ATTACHMENT 6

Memorandum

Date: 18 May 2017
To: Colin Olness, Atlantic Coast Pipeline (ACP)
From: Logan Brant, Ph.D., P.E. and Tony Rice, P.E.
Copies to: Rodolfo Sancio, Ph.D., P.E.
Subject: Response to Forest Service Item No. 6 – 14 May 2017 Letter Captioned
“Reiteration of Previous Information Requests”

Figure 4a. Average Slope Inclination for the Existing Ground

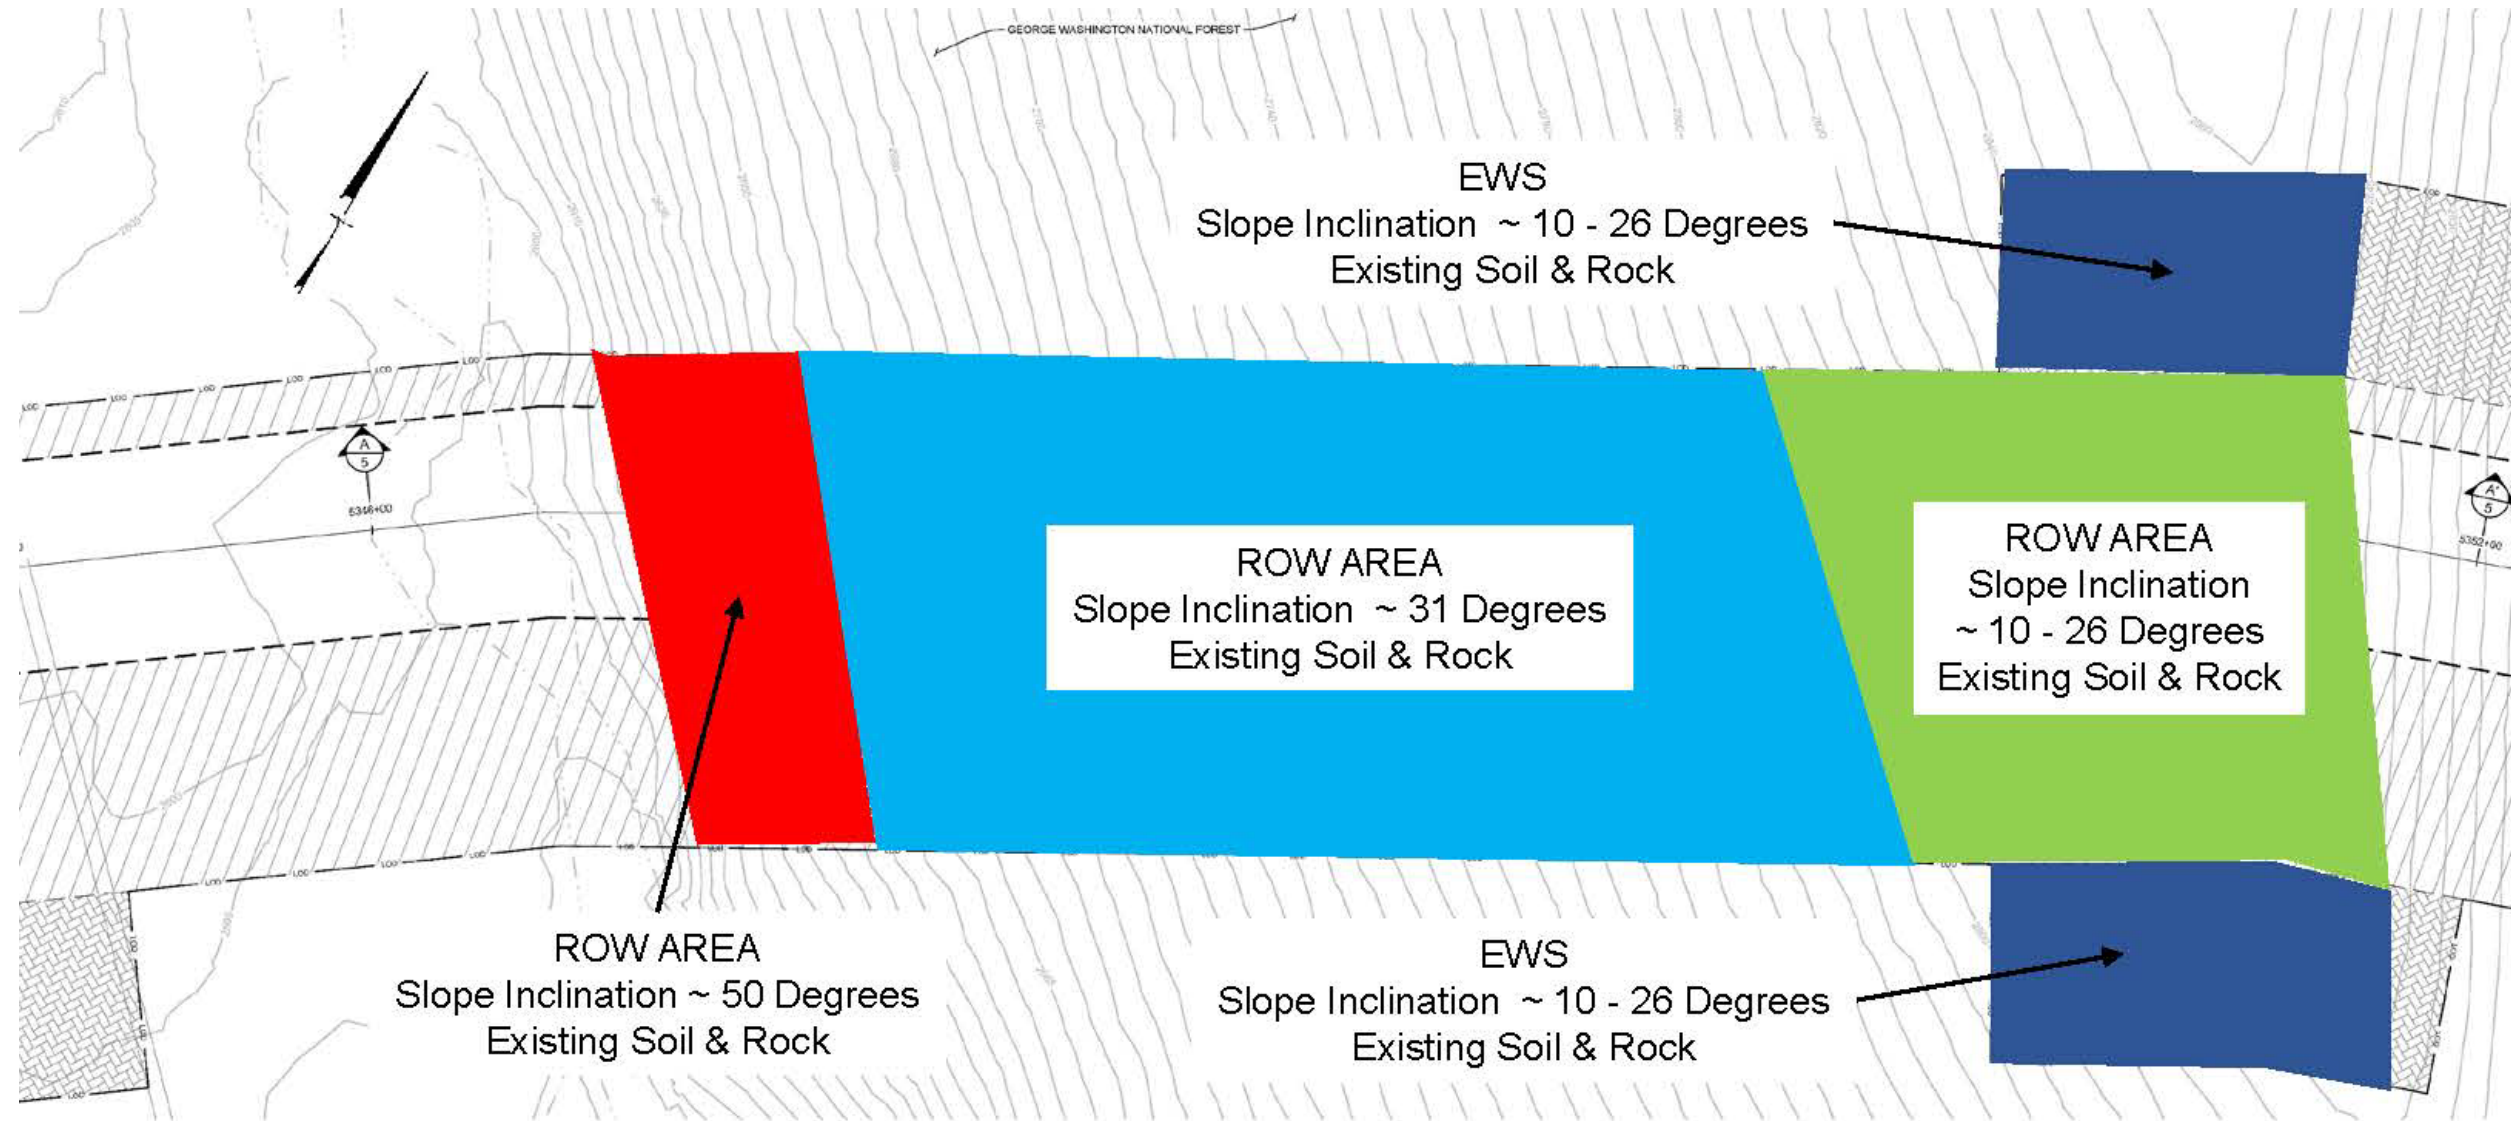
6. *For the GWNF02 site, the Computation Analysis Package Geohazard Mitigation Design at ACP AP-1 MP 84.95 to 85.05 (TXG0007-013-CA-002) shows a plan to place the temporary spoils in the Extra Workspace (EWS) straddling the ridgetop (Figure 4. Anticipated Average Slope Inclination Values for the Temporary Ground). The Cut-Fill Volume Calculations (Figure 6) show 1) a cut on the ridgetop for the winch pad, and 2) a fill 6-10 feet deep in a relatively small area in the EWS south of the cut on the ridgetop. However, Figure 6 also shows a fill 6-10 feet deep covering a larger area that is not in the EWS, but rather is on the steep side slope between contour elevations 2770' and 2830'. Similarly, Figure 6 shows fills 0-3 and 3-6 feet deep covering a larger area that is not in the EWS but rather is on the steep side slope between contour elevations 2650' and 2830'. These fills*

(0-10 feet deep) are temporary spoils that are not in the EWS but rather on steep side slopes which include slope inclinations of 37 degrees (Figure 4). Provide the excavation source for the temporary spoils placed on the steep side slopes between contour elevations 2650' and 2830'. Identify whether these temporary spoils on steep side slopes include material excavated from the ridgetop for the winch pad.

In order to improve clarity and address concerns, we propose to add another figure, Figure 4a, illustrating the slope inclinations for the existing ground and rename the current Figure 4, Figure 4b. These figures, combined with the current Figure 5, would summarize the average slope inclinations for each of the three ground surface configurations; existing ground (Figure 4a); temporary ground (Figure 4b); and final ground (Figure 5). Additional information has also been added to each of the three figures to show the anticipated surficial materials at various locations and the general movement of excavated spoils during each subsequent stage of construction. The proposed updated Figures 4a, 4b and 5, are presented as follows:

Figure 4b. Anticipated Average Slope Inclination for the Temporary Ground

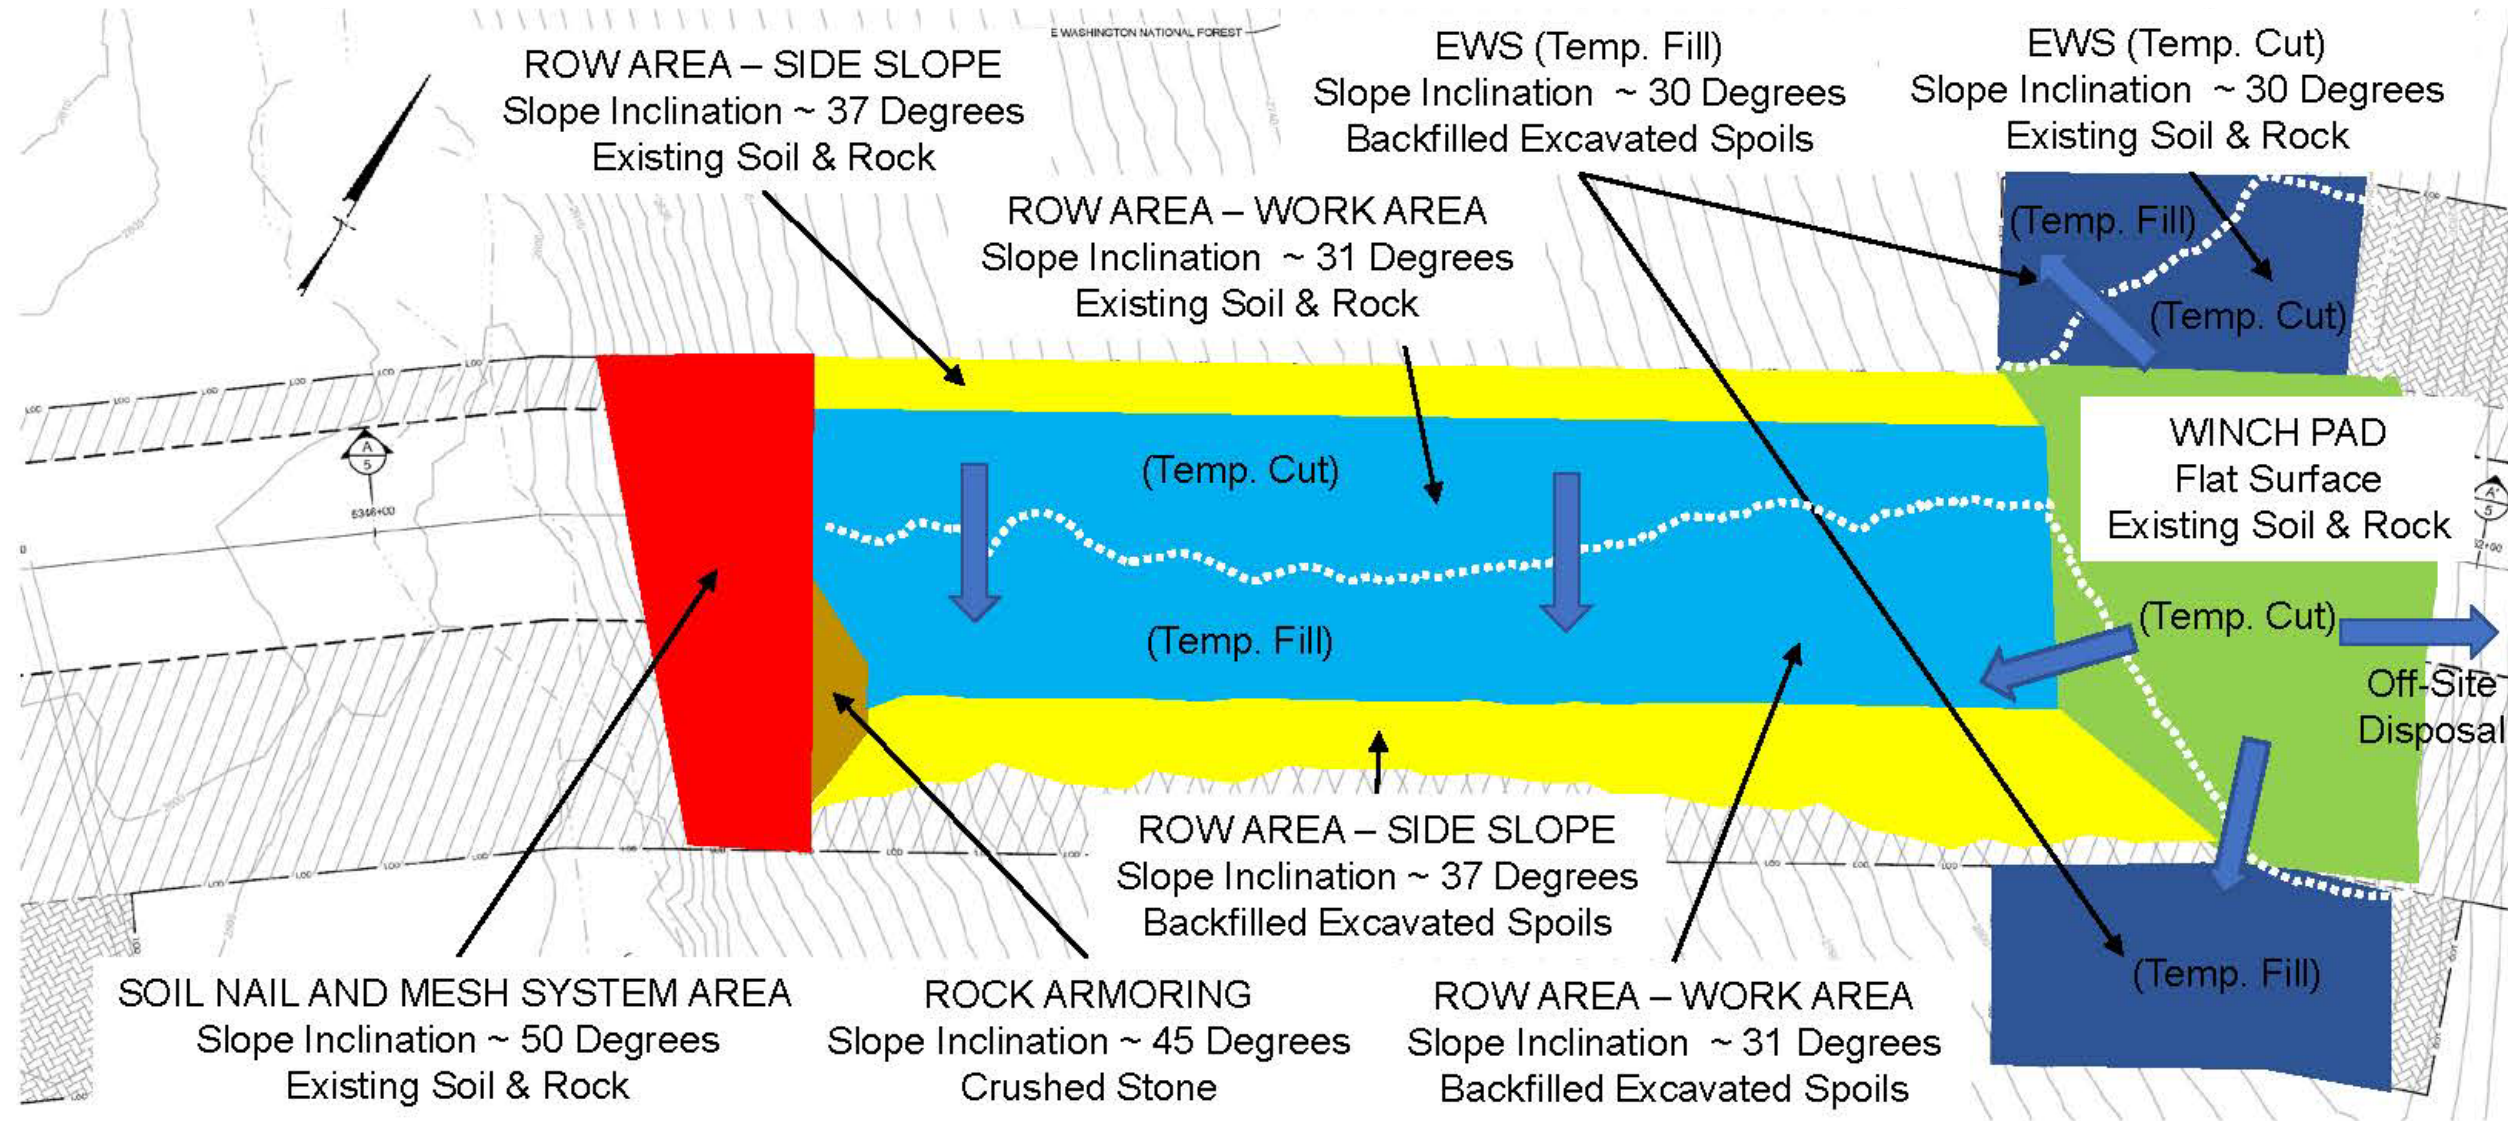
The two parts of the computation package which appear to have caused the most confusion are Table 4 and Figure 4, which it seems did not clearly explained that temporary spoils may be stored

Figure 4 presents the “Anticipated Average Slope Inclination Values for the Temporary Ground” condition during pipeline construction. The slope inclinations shown on this figure for the temporary ground condition are generally different from the existing slope inclinations. The

computation package originally did not contain a figure showing the slope inclinations for the existing ground.
